**CITY PLAN COMMISSION****THURSDAY, MARCH 07, 2024****FILE NUMBER:** S234-054**SENIOR PLANNER:** Hema Sharma**LOCATION:** Woody Road, southwest of C F Hawn Freeway**DATE FILED:** February 08, 2024**ZONING:** R-7.5(A), R-10(A)**CITY COUNCIL DISTRICT:** 8**SIZE OF REQUEST:** 0.626-acres**APPLICANT/OWNER:** Lux Homes Corporation

**REQUEST:** An application to create one 0.312-acre (13,609 square foot) lot and one 0.314-acre (13,675 square foot) lot from a 0.626-acre tract of land in City Block 8806 on property located on Woody Road, southwest of C F Hawn Freeway.

**EXISTING AREA ANALYSIS MAP**

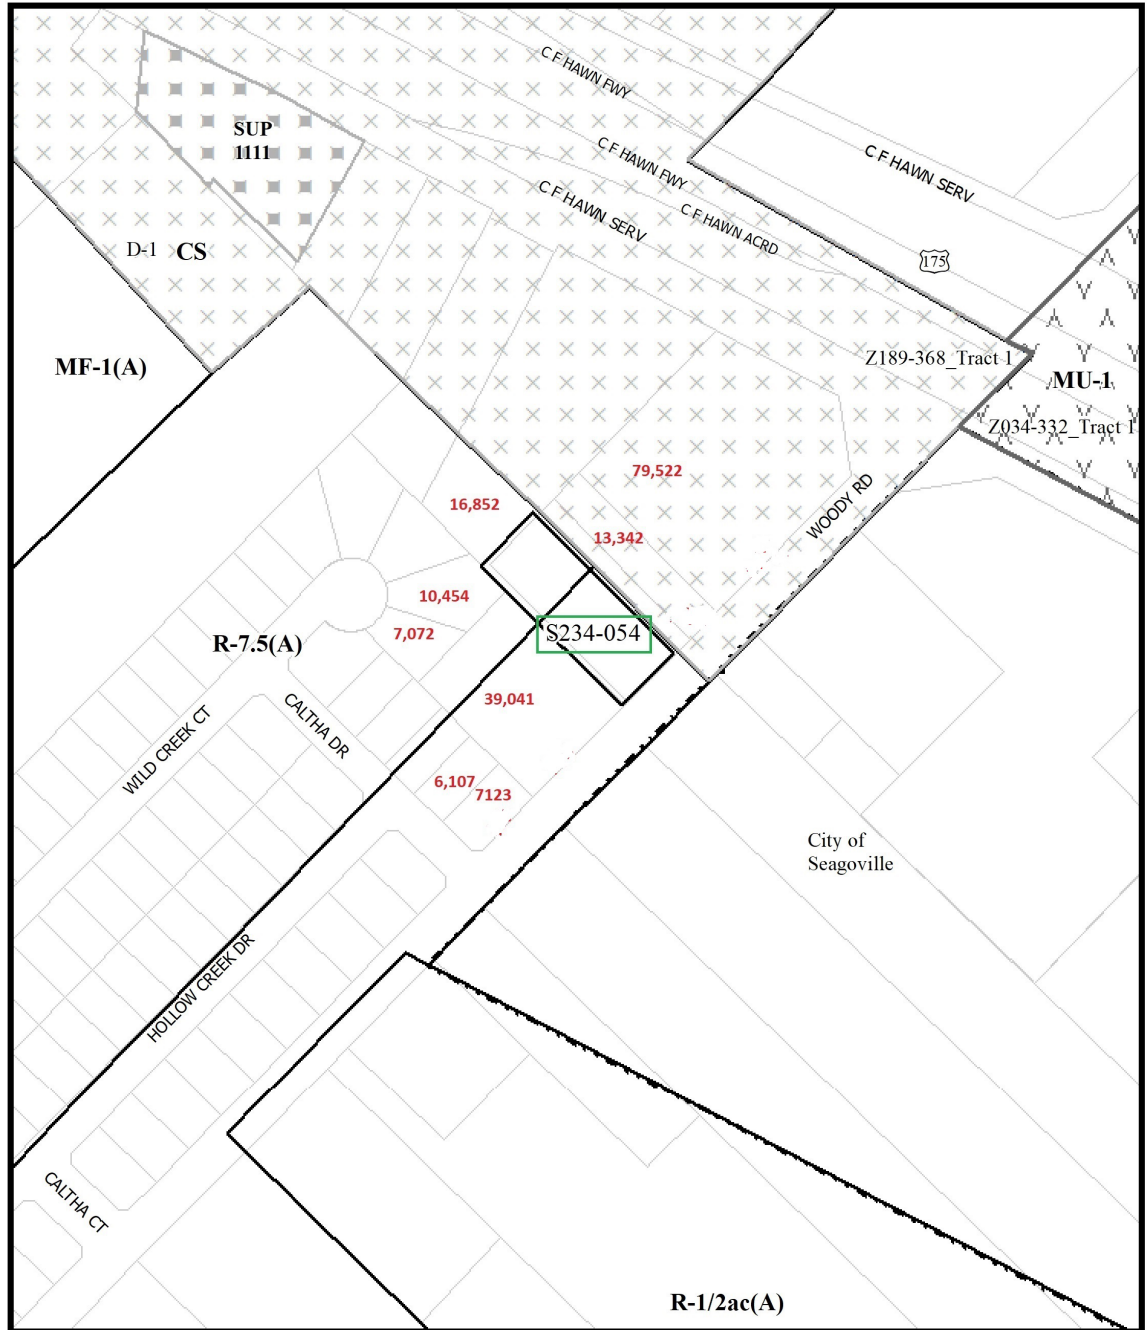
- The properties to the northwest line of the request have areas ranging in size from 6,690 square feet to 79,522 square feet and are zoned R-7.5(A), R-10(A). *(Please refer to the existing area analysis)*

Staff finds that there is a variation in lot pattern within the immediate vicinity of the request (*Refer to the existing area analysis map and aerial map*). The request complies with the zoning requirement of the R-7.5(A), R-10(A) Single Family District and is in compliance with Section 51A-8.503; therefore, staff recommends approval subject to compliance with the following conditions.
